**Melbourne Regional Landfill
 Works Approval Application 1002191
 Section 22 Notice Additional Information – Groundwater Levels**

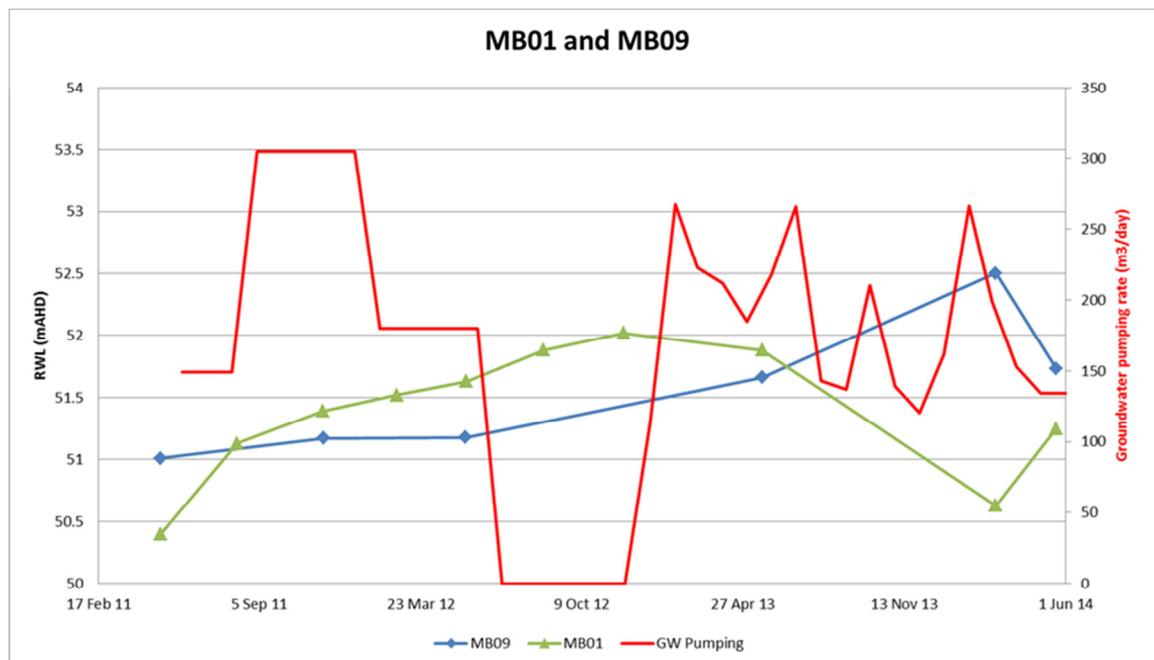
The monitoring record for groundwater levels and pumping is very coarse - bores are read every 3 months and groundwater pumping records have been read monthly since the start of 2013 but before that the average data seems to be lumped into 3 month or 6 month intervals. Plotting the combined daily pumping rate against the levels in bores MB01 and MB09, which are close to the pumping bores, provides the following graph.

According to the pumping records I've been given, there was no pumping between June 2012 and Jan 2013, but I suspect that this is because no data was available. Regardless, this is a very non-conclusive plot. It shows that groundwater levels in MB01, tapping 18.5 to 30.5m depth, rose from early 2011, even though pumping was occurring and continued to rise until March 2013, when levels started to decline. In MB09, however, which is tapping a deeper aquifer (51 to 57m) at the same location, groundwater levels showed a continual upward trend, in spite of the pumping.

The groundwater extraction bores labelled Bores 1 to 4 are constructed at depths of 55, 36, 52 and 37m depth respectively. The plots show there is not a significant relationship shown between the operation of the bores and the levels in the deep aquifer from which they extract.

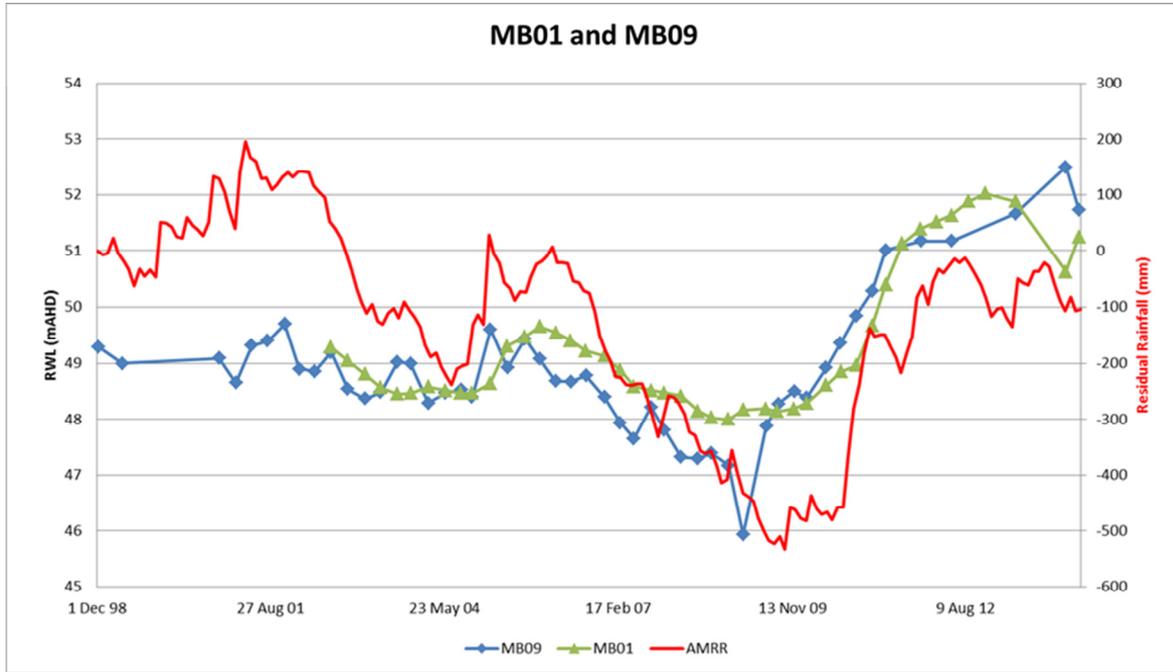
In contrast, when you consider the longer record of groundwater levels plotted against residual rainfall mass, there is a much stronger relationship (refer plot below). This plot shows the dominance of seasonal recharge over pumping in impacting groundwater levels.

I therefore suggest that the analytical data provides a better indication of what is occurring on the site and the relative importance of seasonal impacts on groundwater levels compared with local groundwater extraction.
